# APPROVED MINUTES

## June 18, 2020 Standards Committee Meeting

RE: Minutes from the June 18, 2020 Standards Committee Meeting

RECURRING PLAN DETAIL NO. 801-T-227d

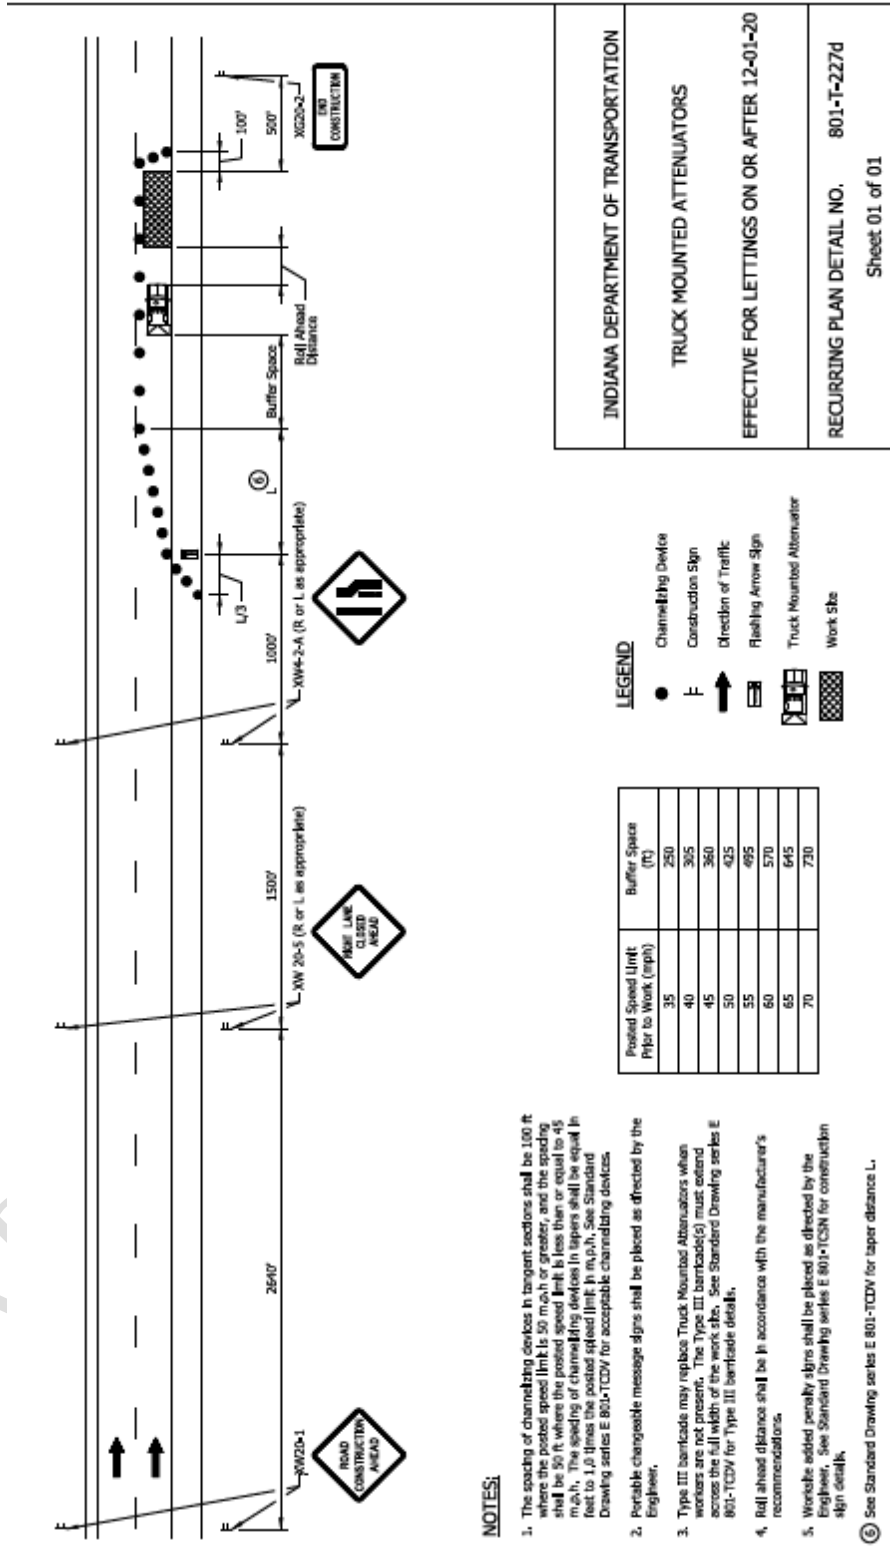
Mr. Bruno confirmed that he has reviewed this USP on a regular basis and provided further clarification. As for the RPD, the details shown illustrate the most current standards and practices. Mr. Reilman inquired about the speeds shown and Mr. Bruno and Ms. Smutzer confirmed that those speeds are correct. Ms. Smutzer proposed having language that the equipment is approved for use if the eligibility letter is not available. Ms. Smutzer also asked if Work Zone Safety has provided any input. Mr. Boruff offered that we could specify that all equipment shall be in proper working condition, of which that language already exist in the special provision. Mr. Kachler offered that he could find no specific material requirements in ATTSSA for TMAs.
